## Executive Director's Recommendation

Commission Meeting: April 5, 2018

<b>PROJECT</b> <b>South Mall Campus Master Plan</b> National Mall, between 7 <sup>th</sup> Street, SW, Jefferson Drive, SW, 12 <sup>th</sup> Street, SW, and Independence Avenue, SW Washington, DC	<b>NCPC FILE NUMBER</b> 7630
<b>SUBMITTED BY</b> Smithsonian Institution	<b>NCPC MAP FILE NUMBER</b> 1.41(05.00)44719
<b>REVIEW AUTHORITY</b> Approval of Master Plans for use by the Commission per 40 U.S.C. § 8722(a) and (b)(1)	<b>APPLICANT'S REQUEST</b> Approval of comments on draft master plan
	<b>PROPOSED ACTION</b> Approve comments as requested
	<b>ACTION ITEM TYPE</b> Staff Presentation

Draft Master Plan

**Figure 1**

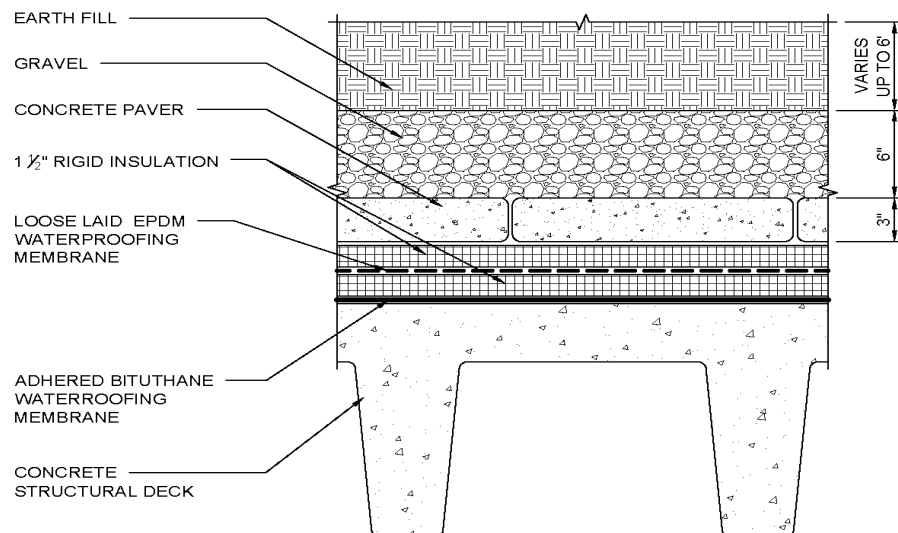
In reference to repairs/replacement of the Quad complex roof, I offer the following:

Completed in 1987 by the General Services Administration, the Quad Complex is a subgrade building comprising the Arthur W. Sackler Gallery, the National Museum of African Art and the S. Dillon Ripley Center. The Quad Complex has a footprint of approximately 129,000 square feet of which the roof is the substrate on which the Haupt Garden is built. The roof assembly is: the structural concrete roof slab; a rubberized asphalt waterproofing membrane adhered to the concrete; rigid insulation board; a loose laid ethylene propylene dien monomer (EPDM) sheet membrane; rigid insulation board; concrete pavers; a gravel drainage layer; and, earth overburden of 4-6 feet in depth.

Within the waterproofing industry, the typical and preferred practice of waterproofing is to provide positive-side waterproofing; this is the most effective means for preventing water intrusion. That is why all buildings have roofing membranes and foundation walls are waterproofed on the outside surface. The Quad's deck is the roof and the roofing membrane system is installed on its exterior surface. The exterior waterproofing system on the Quad protects the occupants of the building as well as the materials inside, and the structure on which it is installed. If a below-grade reinforced concrete structure were not waterproofed, moisture would migrate into the concrete, cause the concrete matrix to break down and deteriorate, expose the steel reinforcing to the moisture which will in-turn cause it to rust and deteriorate. The structure would continue to deteriorate until it is no longer sound.

In the written testimony of the National Capitol Planning Commission meeting of 4 January 2018, a comment was made that "leaking roofs below the Quad can be repaired from below. We need look no further than the remediation of the underground station ceilings now underway in Washington's Metro system". In my opinion as a waterproofing and building envelope expert with 31 years of experience, this is an incorrect statement. At the Quad, we are referring to a flat expansive roof deck; this below-grade building is in no way considered a tunnel. Tunnel ceilings are not flat, and the injection is performed to plug the hole for that specific leak through the concrete.

If we apply the injection concept to the Quad roof, the injection would have to occur at every leak location. Knowingly that water will continue to flow across the deck to the next point of entry, those locations would then also have to be injected. The problem here is that the leak would have to first occur to find the next location for injection. This is a reactive response not a proactive solution. This is also an admission that the original waterproofing system has failed.

It is our opinion that this roofing assembly represents a failed, unconventional approach and to provide a viable waterproof envelope for the buildings below, removals down to the deck are necessary.
